**AGENDA  
REGULAR PLANNING COMMISSION MEETING  
128 S. MAIN STREET, CONDON, OR 97823  
TUESDAY, JUNE 20, 2023, 5:30 PM**

Condon Early Learning Center  
CELC Expansion  
311 East Bayard ST  
Condon, OR 97823

<b>TO</b>	City of Condon				
<b>FROM</b>	Jeff Schott, P.E.				
<b>PROJECT</b>	Condon Early Learning Center Expansion				
<b>SUBJECT</b>	Site Plan & Conditional Use Application- NARRATIVE				
<b>DATE</b>	4/25/2023	<b>PROJECT #</b>	2022-048	<b>MEMO #</b>	EM-001

<b>TO</b>	Kirk Fatland, Planner, Tenneson Engineering City of Condon				
<b>FROM</b>	Jeff Schott, P.E.				
<b>PROJECT</b>	Condon Early Learning Center Addition				
<b>SUBJECT</b>	Staff Review Responses				
<b>DATE</b>	6/12/2023	<b>PROJECT #</b>	2022-048	<b>MEMO #</b>	EM-02

**1 SITE PLAN**  
C101

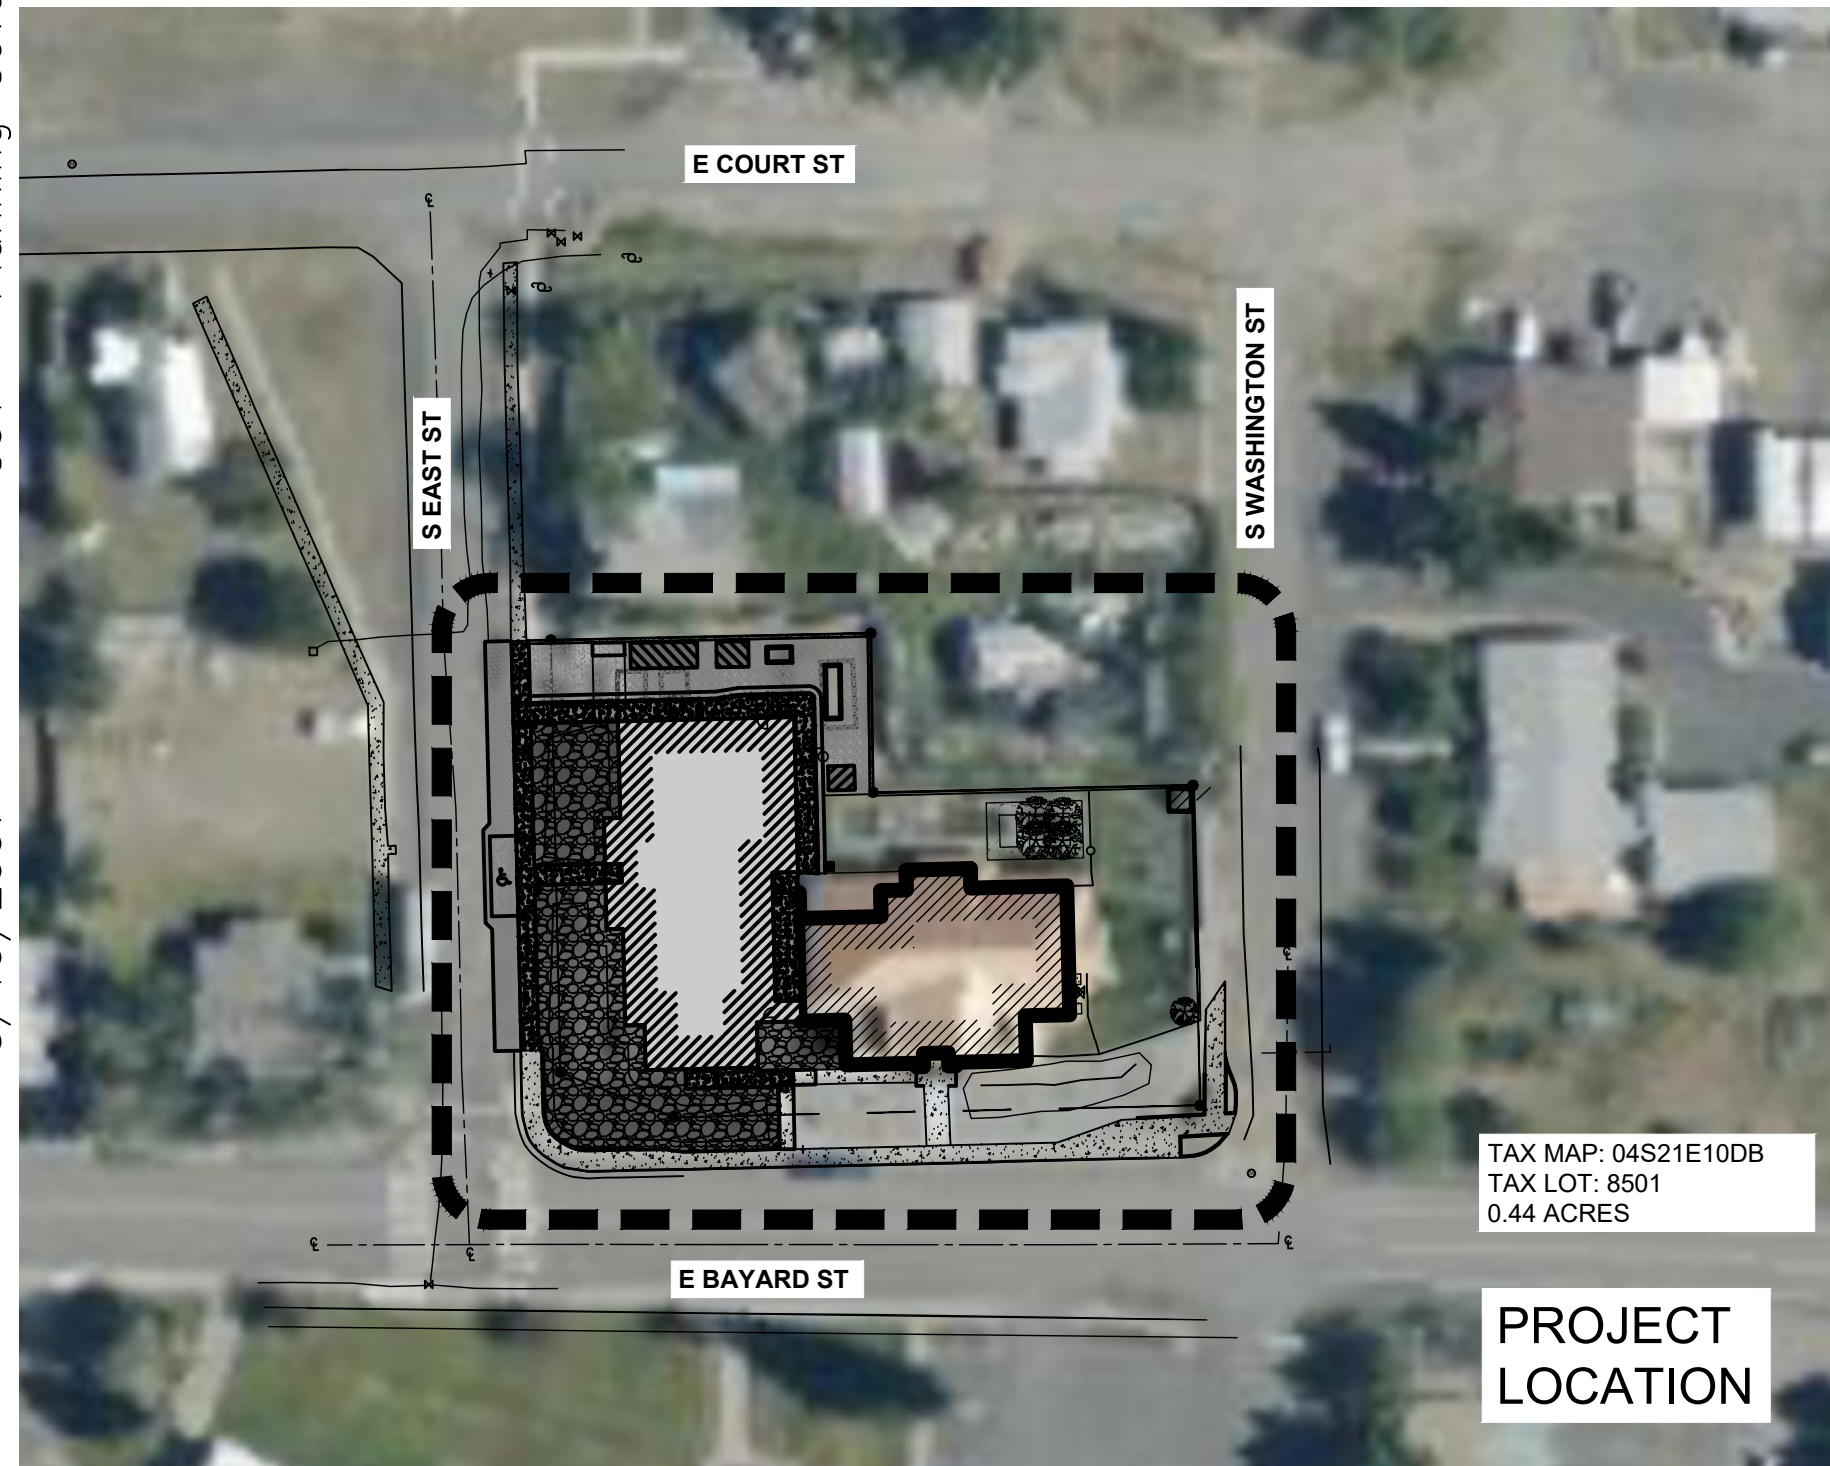
**FINDING:** The applicant proposes removing over 50 cubic yards of material from the site requiring approval of the Planning Commission. The existing stormwater management swales to the north and south of the existing parking area are shown to be removed. Rock lined swales are proposed to be installed along the south and west sides of the site. Please see the relevant proposed condition of approval.

City Sewer The proposed discharge of a new sewer service to the existing manhole southeast of the proposed development appears reasonable. If a connection to the existing sewer service line upstream of the existing manhole in the intersection of E. Bayard and S. Washington Streets cannot be accommodated, a design drawing showing the intent of the new connection to the existing manhole and maintaining a watertight manhole will be needed prior to construction.

swales. The proposed site plan shows new rock lined swales being installed. The proposed development will increase impervious area and stormwater runoff generated on the site. Please see the relevant proposed condition of approval.

*ODOT provided staff comments suggesting that the parent pick-up/drop off be relocated to East Street rather than Bayard Street. This would result in the need for a revised layout of the East Street access and ADA parking layout.*

*The proposed discharge of a new sewer service to the existing manhole southeast of the proposed development appears reasonable. A design drawing showing the intent of the connection to the existing manhole and maintaining a water tight manhole will be needed prior to construction.*

*The proposed project proposes removal of two existing storm drain swales. It does not appear that replacement of the swales is shown on the proposed site plan. The*

*It is requested that the developer's engineer submit (in the design phase) storm drain calculations showing that the runoff generated by a 25-year storm event on both the proposed and existing site (due to proposed modifications to existing storm drain swales) be less than or equal to the flows leaving the site prior to the development occurring.*

*Drawing notes "Primary loading/unloading area" on the highway. What is the intent for this area? If it is true parent pick-up/drop-off, suggest relocating to East Street.*

*The proposed stormwater plan notes to expand the existing swales and retain the 2 or 5 year storm. ODOT's criteria would be that the pre and post development flows are the same or less for the 25-year design storm. Please provide documentation that shows this.*

If the slope and elevation of the existing drainpipe allows for it, we will connect the addition's drain to the existing building drain and not have to make a separate connection to the manhole. If we must make a new connection to the manhole, we will submit a detail to the City for a sealed connection. We hope to avoid a separate connection.

We do not intend to completely remove the existing storm-water swales. We plan on eliminating portions of one swale but expand the other along the new addition and incorporate them into the landscaping using large open-graded rock to minimize the exposed depth of the swale. We may fence off the open part of the swales to minimize a drowning hazard for children.

The current system appears to function largely by infiltration of the storm swales. We intend to use the same method in shallow swales. We are planning on doing some infiltration testing with the geotechnical investigation later this summer. However, if we are required to detain to the 25-year event, we may need to install UIC's (aka drywells) or a pumping system to discharge water earlier in the storm event. These will necessarily increase the cost and complexity of the project.

If our design requires discharge to the ODOT right-of-way we will comply with the ODOT guidelines and provide documentation to ODOT.
